COLLIN COUNTY
FRONTIER PARKWAY PAVING AND DRAINAGE IMPROVEMENTS
Dallas North Tollway to S.H. 289 (Preston Road)
Project No. IFB 2020-303

CHANGE ORDER NO. 6

SHEET NO.
D16

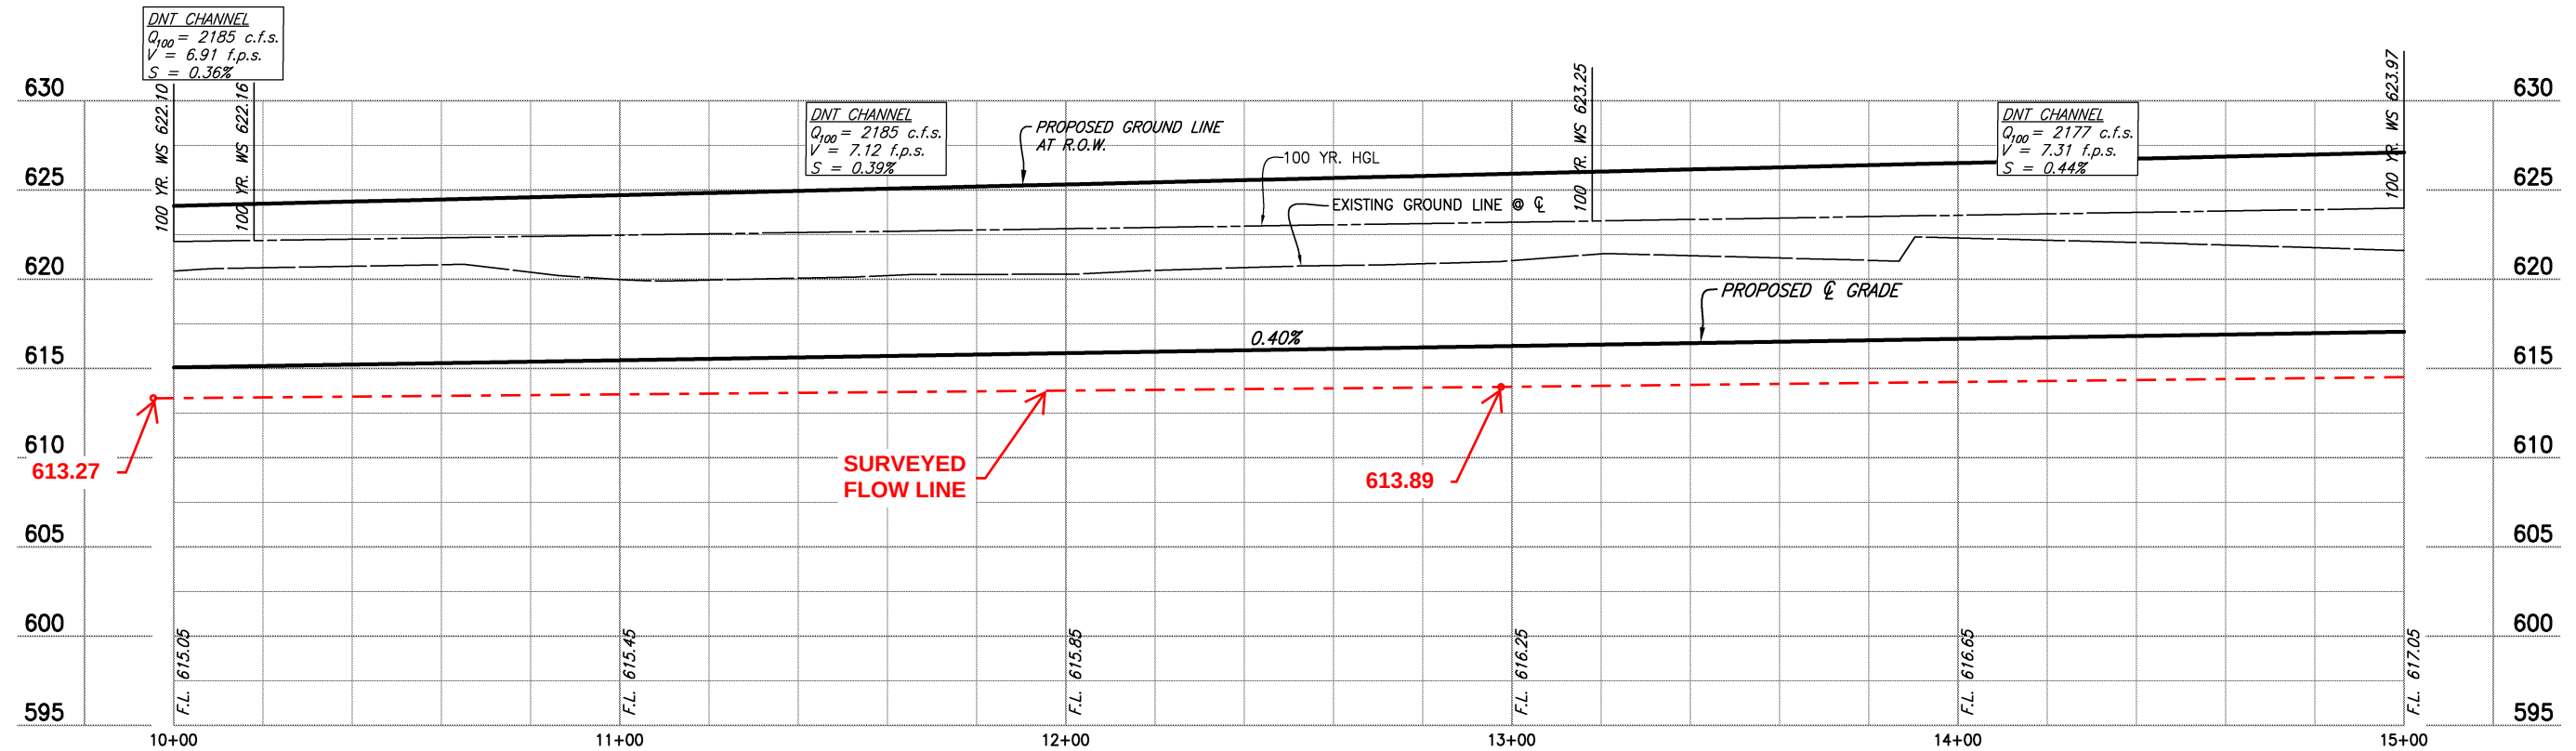
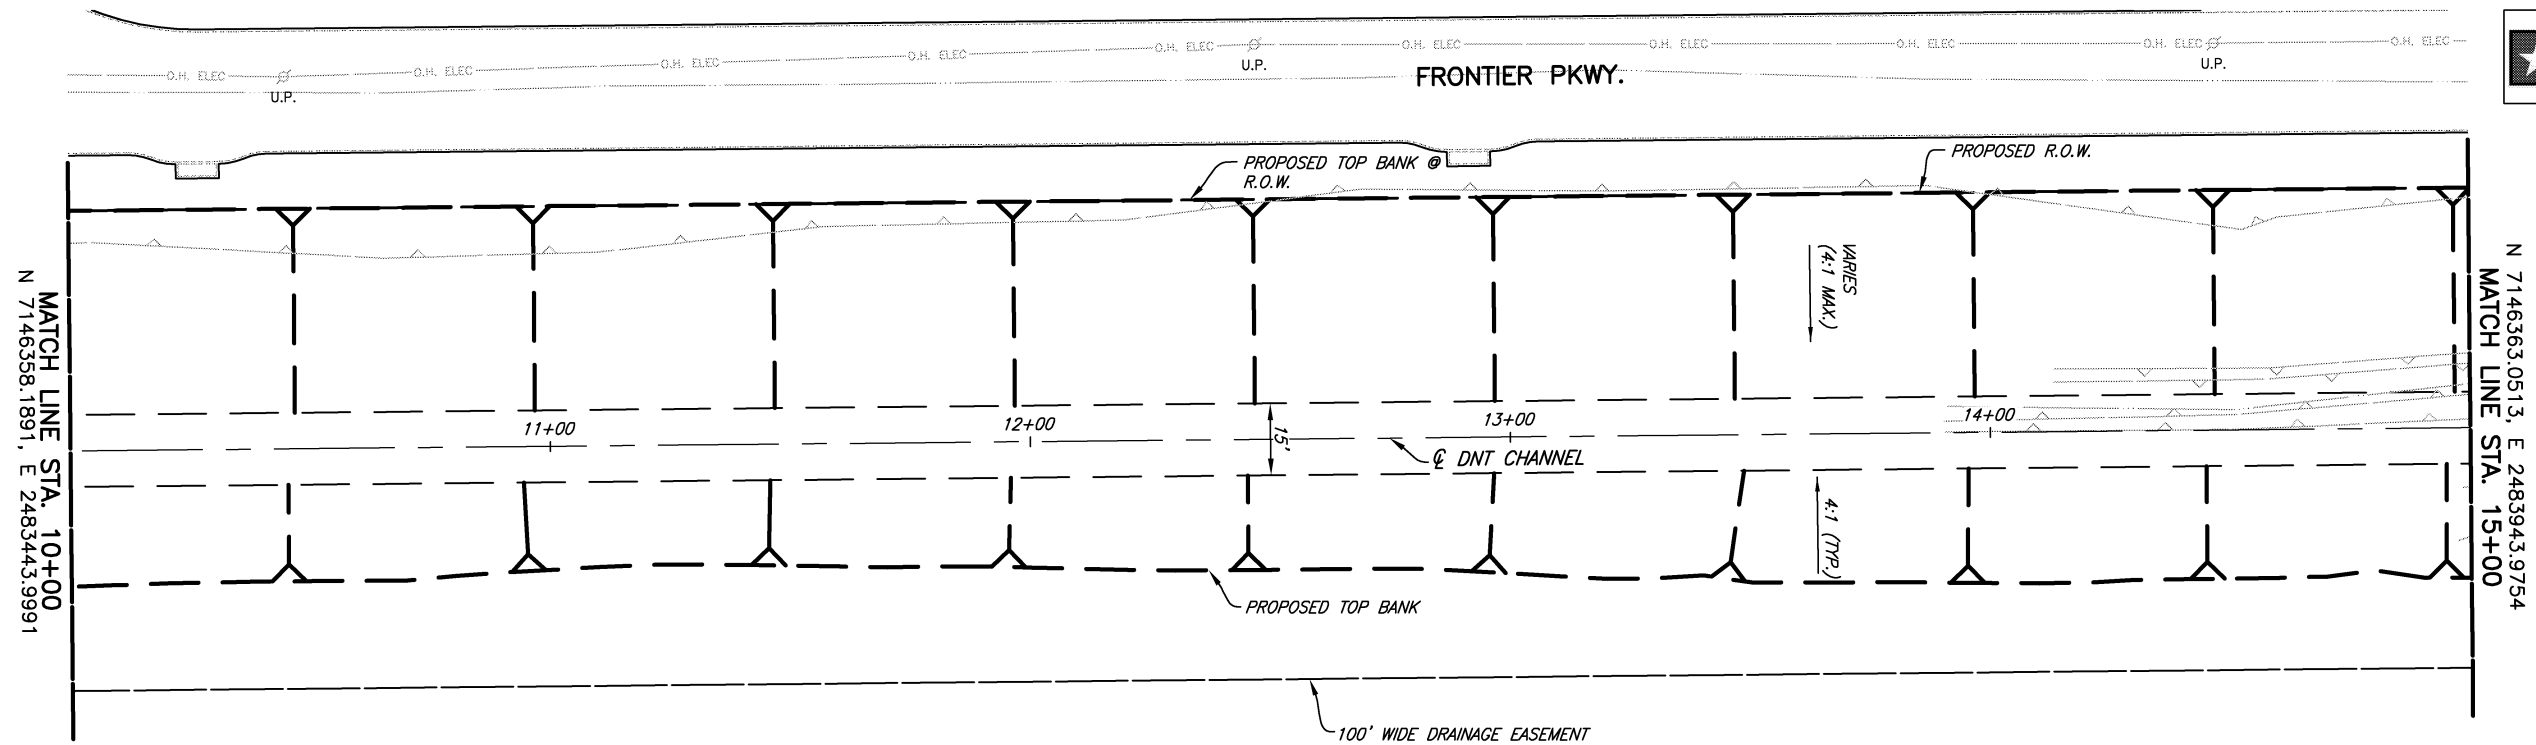
- a) Regrading the channel from the downstream edge of the existing gabion mattress to match the existing channel flowline 300 feet downstream.
- b) Constructing a 15-foot wide by 8-inch thick gabion mattress with 18-inch deep toe walls on all sides in the channel bottom from the downstream edge of the existing gabion mattress for a distance of 100 feet downstream.

- c) Constructing a geogrid material infilled with growth media and a Bermuda grass seed mixture on both side slopes for 28-feet (or a height of 7 feet above the channel bottom). The recommended material for the geogrid and growth media is Futerra 7020 TRM and ProGanics Dual, with Platipus Zip anchors in an 18-inch anchor trench as manufactured by Profile Products, L.L.C., contact Matt Skinner at email MSkinner@profileproducts.com and phone 832-773-4030.

- d) Constructing the geogrid material infilled with growth media and a Bermuda grass seed mixture from the downstream edge of the proposed gabion mattress channel bottom to a distance of 200-feet downstream. The geogrid material infilled with growth media and a Bermuda grass seed mixture shall be 28-feet each side of the channel bottom transitioning to 12-feet each side of the channel bottom 200 feet downstream and shall

extend across the channel bottom for the entire 200-foot length downstream of the proposed gabion channel bottom. All the geogrid areas shall be provided with an 18-inch anchor trench on all sides and recommended anchors.

- e) Construction Plan Sheets D15-D19 marked “Change Order No. 6” in the lower left-hand corner of the sheet are attached hereto and made a part of the construction contract.
- 3) Final Construction Quantity Reconciliation (Collin County, Celina, Prosper)
- a) Reconciliation of Under Run Work Item Quantities
 - b) Reconciliation of Over Run Work Item Quantities

SHEET NO.
D18

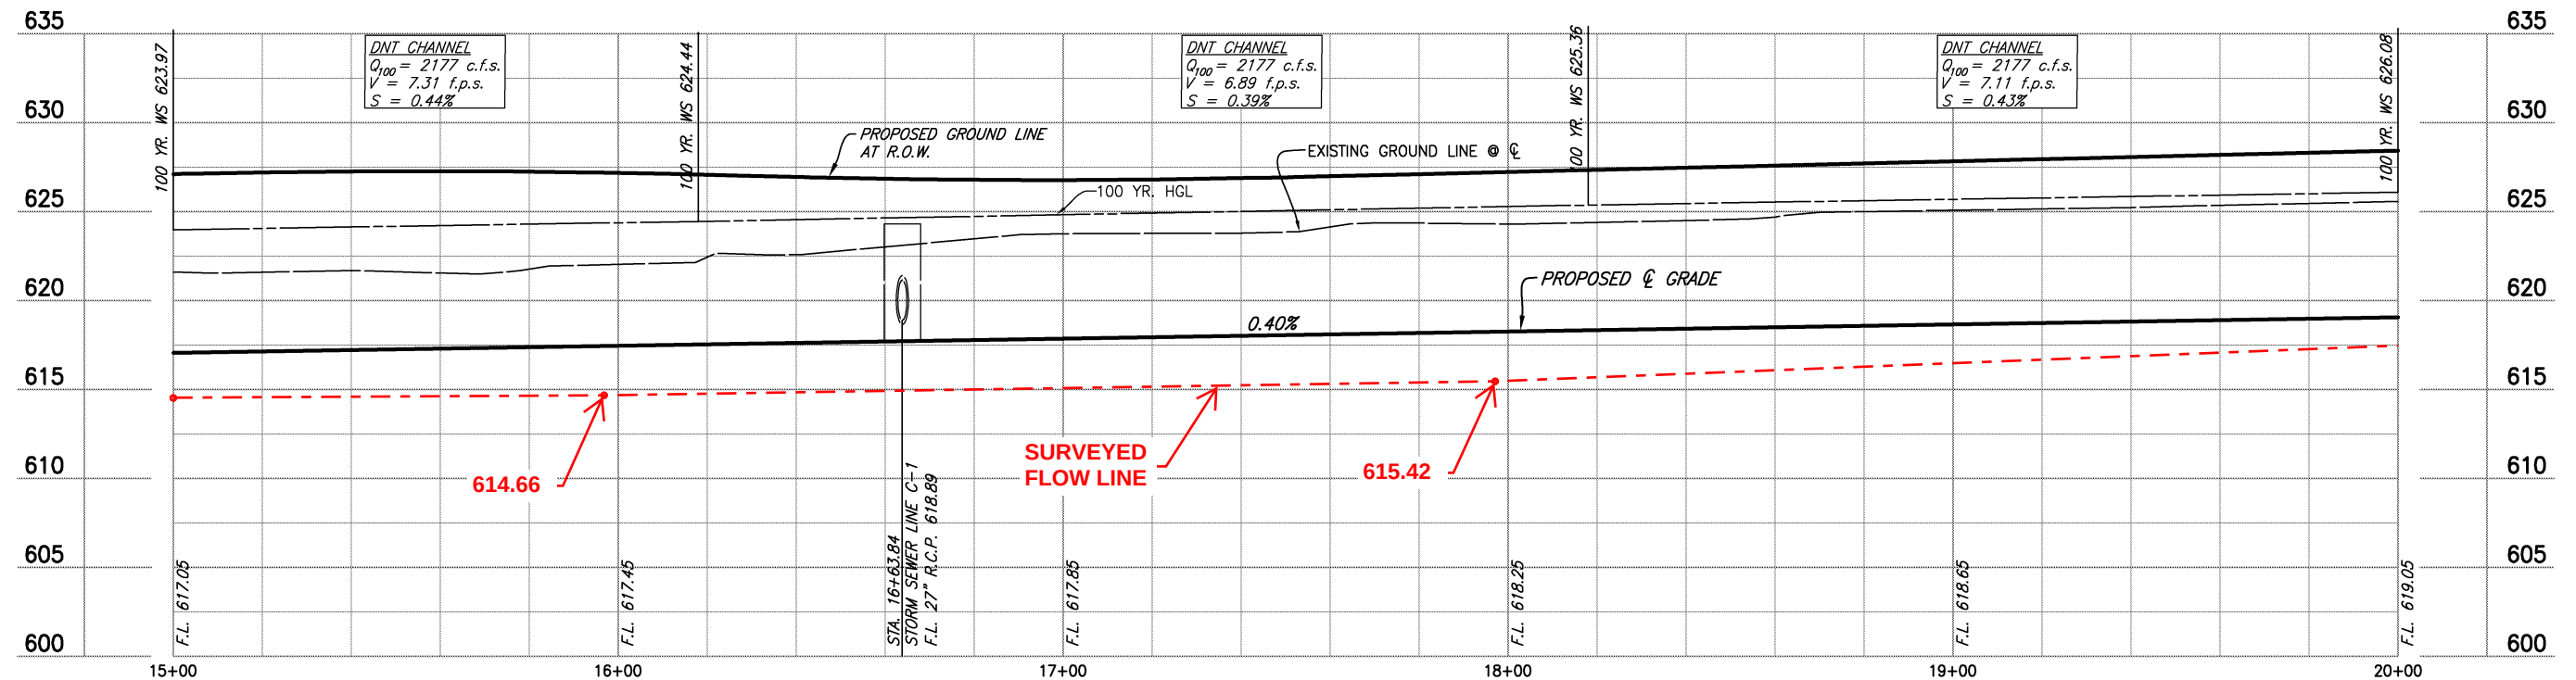
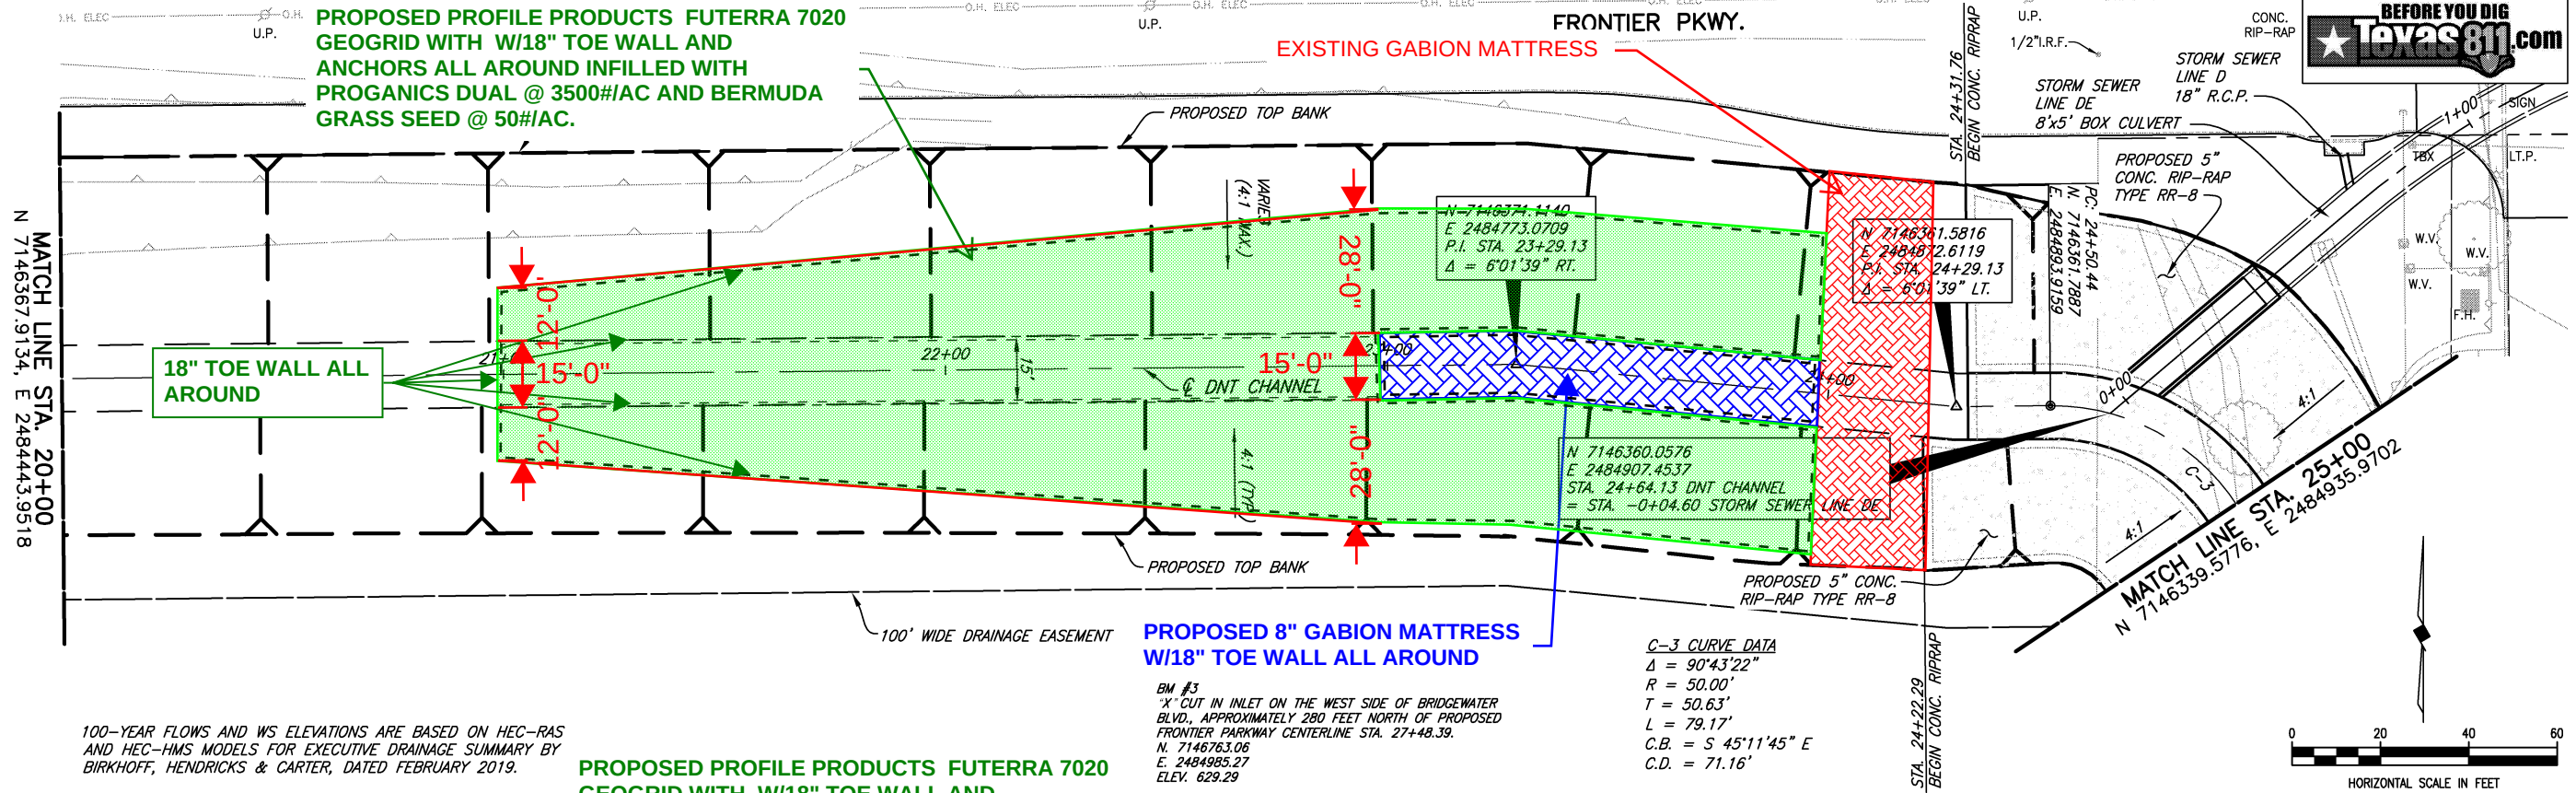
PROPOSED PROFILE PRODUCTS FUTERRA 7020 GEOGRID WITH W/18" TOE WALL AND ANCHORS ALL AROUND INFILLED WITH PROGANICS DUAL @ 3500#/AC AND BERMUDA GRASS SEED @ 50#/AC.

PROPOSED 8" GABION MATTRESS W/18" TOE WALL ALL AROUND
